Subject: Duke Energy Carolinas, LLC
William States Lee III Nuclear Station - Docket Nos. 52-018 and 52-019
AP1000 Combined License Application for the
William States Lee III Nuclear Station Units 1 and 2
Response to Request for Additional Information
(RAI No. 2563)
Ltr# WLG2009.06-04

Reference: Letter from Brian Hughes (NRC) to Peter Hastings (Duke Energy),
Request for Additional Information Letter No. 068 Related to
SRP Section 03.08.05 – Foundations for the William States Lee III Units 1
and 2 Combined License Application, dated April 16, 2009

RAI Letter No. 068

Reference NRC RAI Number(s): RAI 03.08.05-005

Figure 2. Section Model at Northwest Corner Lee Nuclear Station Unit 1

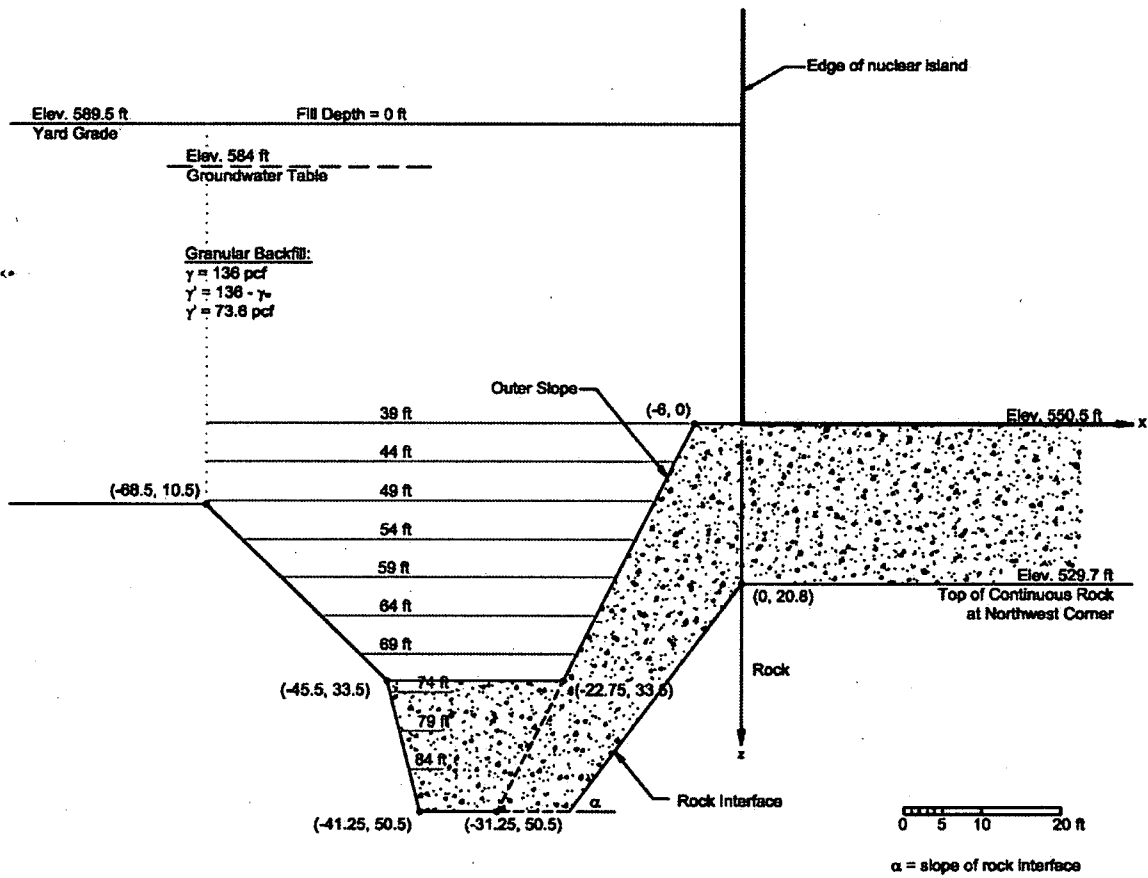
The fill concrete is an essential part of the foundation load path. Without a quantitative stress analysis that accounts for the sloping rock geometry, it is not apparent to the Staff that the margin of safety for the fill concrete in the northwest corner is acceptable.

1. Please identify the allowable stress criteria for the design of the fill concrete (e.g., ACI-318-02 strength criteria for plain structural concrete).
2. Please describe the design analysis that has been or will be performed to verify that stress in the fill concrete is acceptable. Please identify the assumptions about the post-excavation geometry of the continuous rock, including the maximum slope of the rock.
3. Please describe the controls placed on the excavation process that will ensure that the as-built fill concrete geometry is within design assumptions. Also, please identify the post-excavation inspections that will be performed prior to placement of the fill concrete.

2. An analysis has been performed to verify that stress in the fill concrete is acceptable. The assumptions about the post-excavation geometry of the continuous rock, including the maximum slope of the rock are described below. The continuous rock begins to slope at the northwest corner of the Unit 1 nuclear island and slopes down to the north and to the west. The top of the continuous rock slope was kept at elevation 529.7 ft (20.8 ft below the base of the nuclear island) and a range of continuous rock slope angles was postulated from the flattest (4:1 H:V) to the steepest (0.25:1 H:V). The outer slope of the fill concrete begins 6 ft north and 6 ft west of the nuclear island base mat and slopes downward to the north and to the west at (0.5:1 H:V) and connects with the sloping continuous rock at elevation 500 ft as it is depicted on revised FSAR Figures 2.5.4-245 and 2.5.4-246, except where the postulated continuous rock slope is flat enough to intersect the outer slope at a higher elevation than shown on these figures. The plan view of the analyzed foundation model is depicted on Figure 1. The cross section geometric model is depicted on Figure 2, where alpha "α" is the symbol given to the rock slope inclination.

Revised FSAR Figure 2.5.4-245

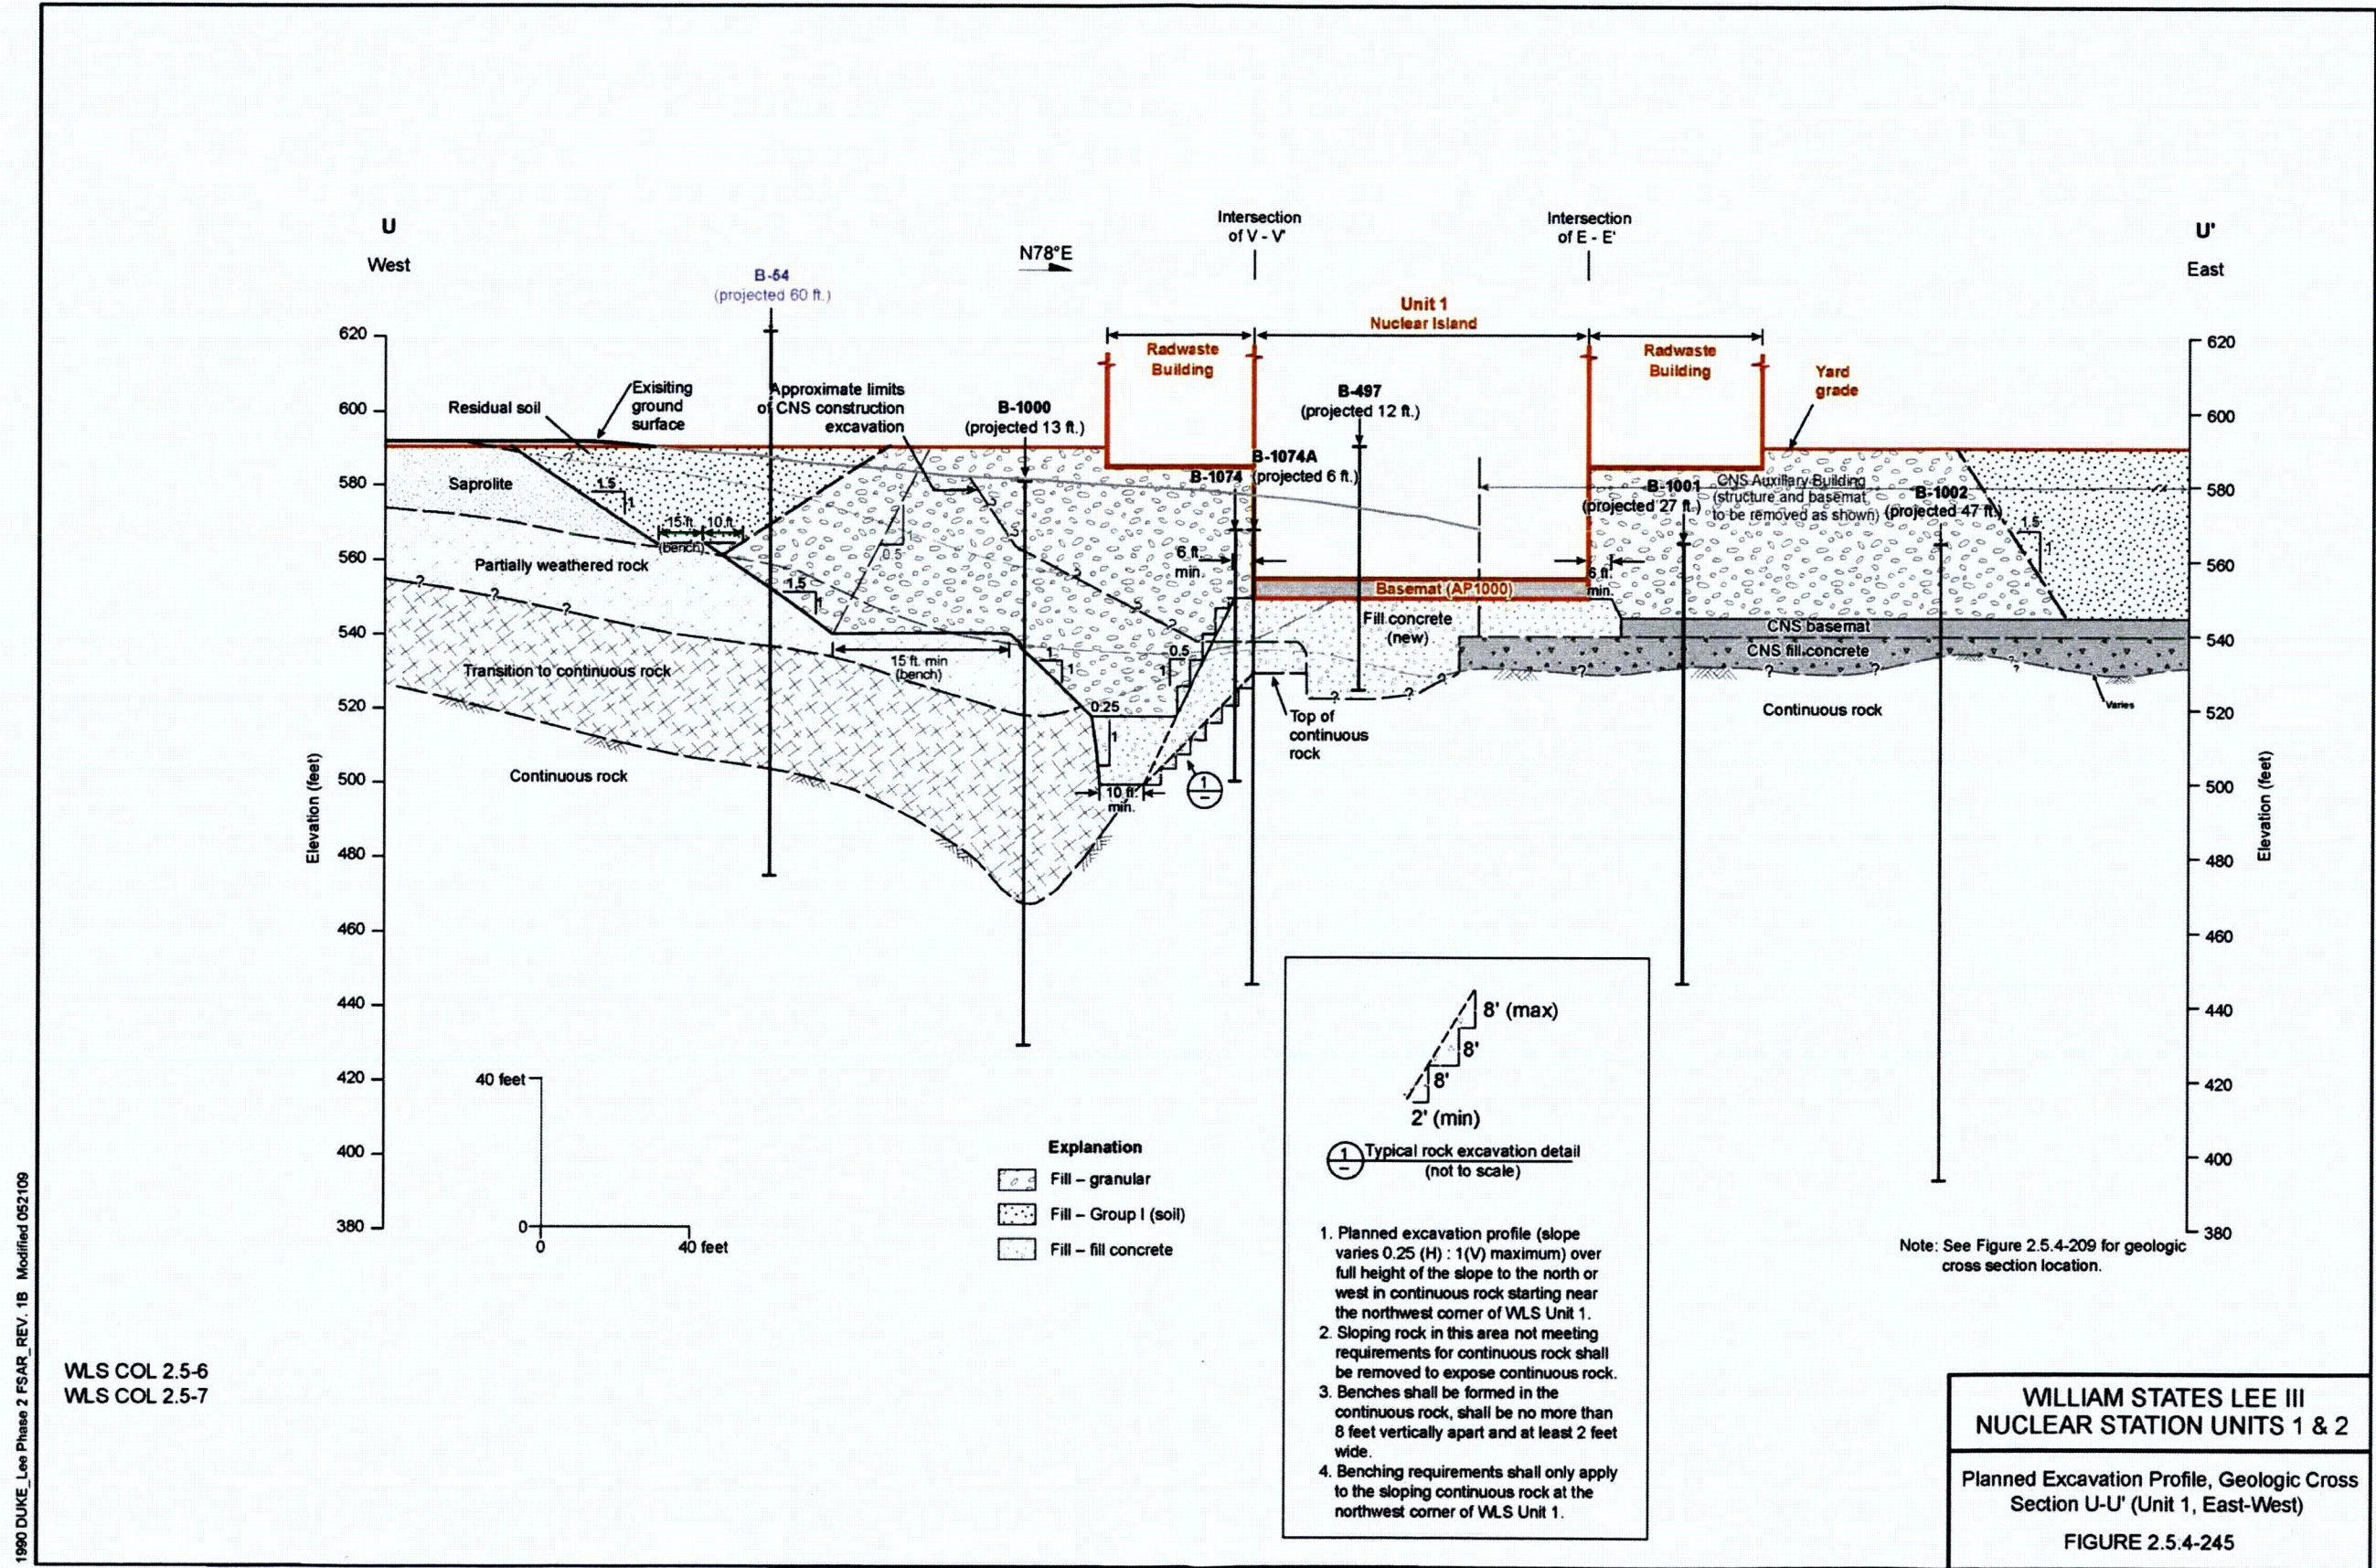
The applicant responded on December 17, 2008. The response states that the sloping rock surface that receives fill concrete will be excavated to form benches in the continuous rock. The benches would provide a horizontal rock face to resist vertical foundation loads. As a result, shear through the fill and at the rock interface would not be a controlling failure mode. Revised Figures 2.5.4-245 and 2.5.4-246 were provided and showed the benches.

The use of benches appears to be a good way to provide a reliable load path to the rock. The text of the RAI response indicates benches will be formed at sloping rock. However the revised figures do not clearly require the formation of benches. Taking Note 2 of either figure literally, benches are required only if sloping rock does not meet the requirement for continuous rock (apparently RQD 65% per FSAR 2.5.4.11). Also, the angle at which a surface qualifies as "sloping" has not been established.

evaluated. The calculated stresses are therefore always acceptable because there is a significant margin between the induced stresses and the allowable stresses for all excavation geometry. On this basis, there is no indicated need for special controls to be placed on the excavation process to ensure that the as-built fill concrete geometry is within design assumptions. FSAR Figures 2.5.4-245 and 2.5.4-246 are revised to clearly show that benches are required in the sloping continuous rock (but only in this northwest corner area to distinguish it from all other areas of the site). The angle at which a surface qualifies as "sloping", which is only relevant to this northwestern corner area, is not a critical limit; FSAR Figures 2.5.4-245 and 2.5.4-246 require benching for any continuous rock slope to support the fill concrete north and west of the northwest corner of Unit 1. The post-excavation observations and geological mapping to be performed prior to placement of the fill concrete are described in FSAR Subsection 2.5.4.5.3.1 and FSAR Subsection 2.5.4.12.

Revisions to FSAR Figures 2.5.4-245 and 2.5.4-246 described above will be incorporated into a future revision of the Final Safety Analysis Report.
